UMC INNER CITY MISSION SUBDIVISION

APPLICATION NUMBER 10 DATE August 17, 2006

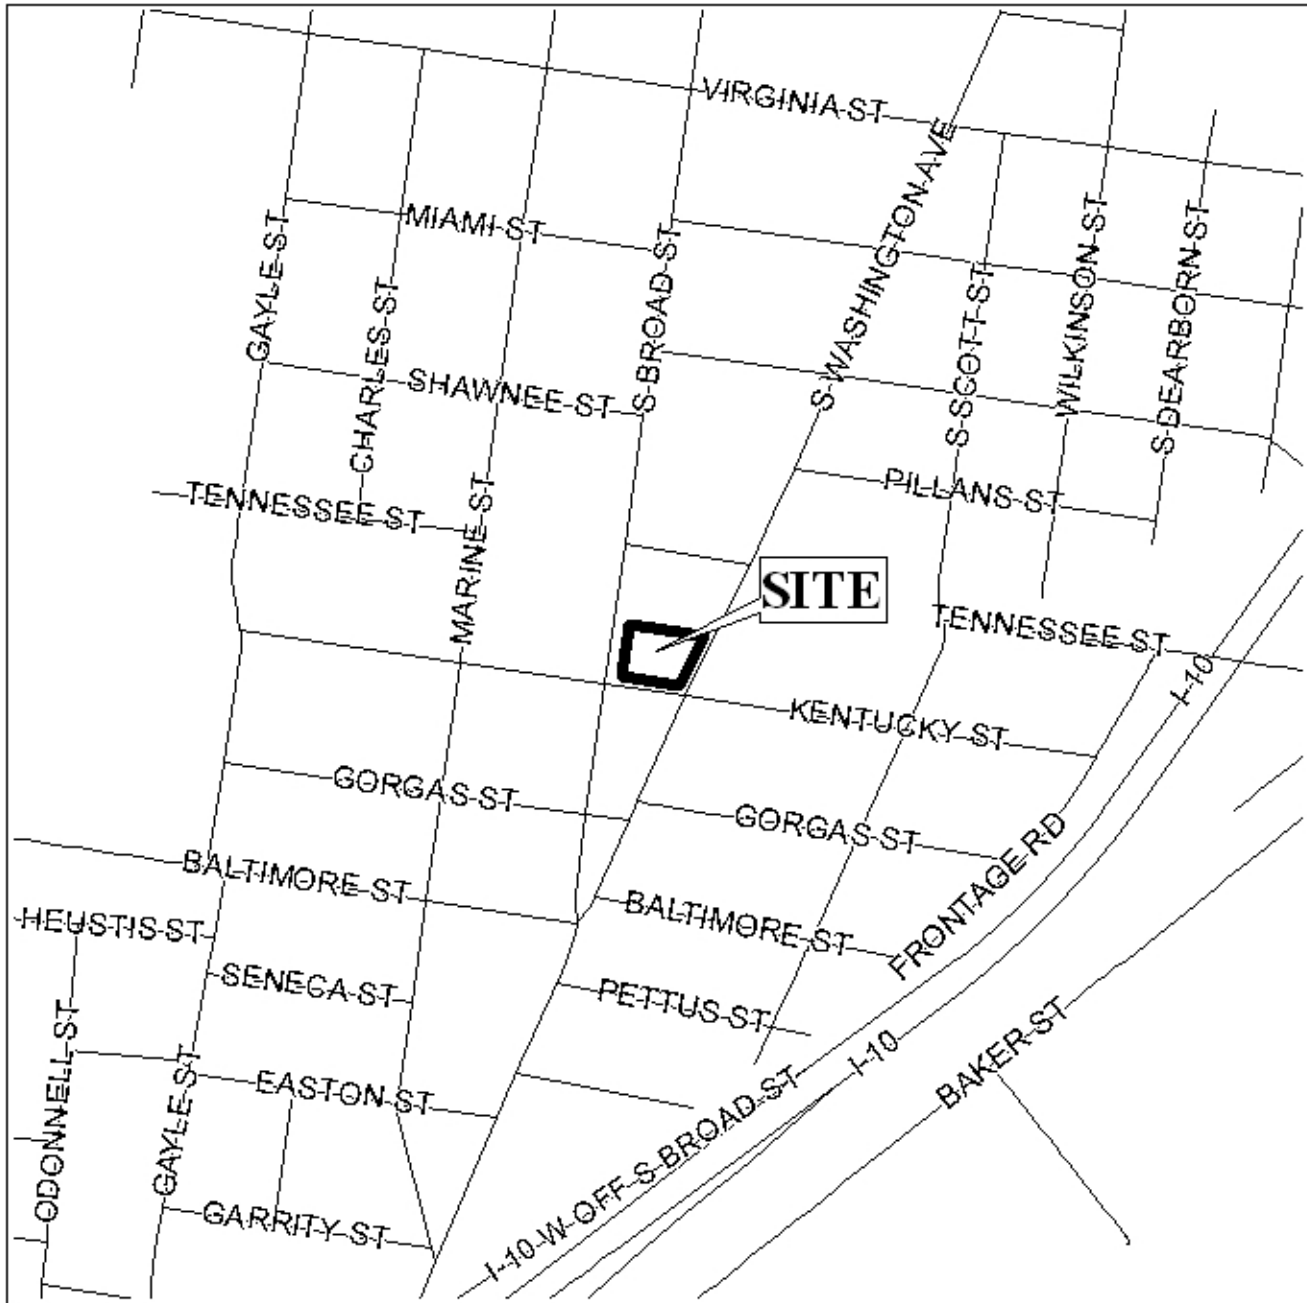
The site fronts South Broad Street, which has an existing right-of-way of 100-feet, is illustrated as a major street on the Major Street Plan and complies with the Plan. The site also fronts Kentucky Street, and South Washington Avenue. As the site fronts a Major Street, access management is a concern; therefore, a note should be placed on the final plat stating that Lot 2 allowed one curb cut onto South Broad Street, Lot 1 allowed one curb cut each onto Kentucky Street and South Washington Avenue, and Lot 3 allowed one curb cut onto South Washington Avenue, with the size, location and design to be approved by Traffic Engineering.

As the site is located on a corner the dedication of a radii at South Broad Street and Kentucky Street; and South Washington Avenue and Kentucky Street should be required, with the size to be determined by Traffic Engineering.

The required twenty-five foot minimum building setback lines are not illustrated on the preliminary plat, but would be required on the final plat.

The plat meets the minimum requirements of the Subdivision Regulations and is recommended for Tentative Approval subject to the following conditions: 1) the placement of a note on the final plat stating that Lot 1 be limited to one curb cut each onto Kentucky Avenue and South Washington Avenue, Lot 2 be limited to one curb cut onto South Broad Street, and Lot 3 be limited to one curb cut onto South Washington Avenue with the size, location and design to be approved by Traffic Engineering; 2) dedication of an appropriate radii at South Broad Street and Kentucky Street; and South Washington Avenue and Kentucky Street, with the size to be determined by Traffic Engineering; and 3) the provision of 25-foot minimum building setback lines on the Final Plat.
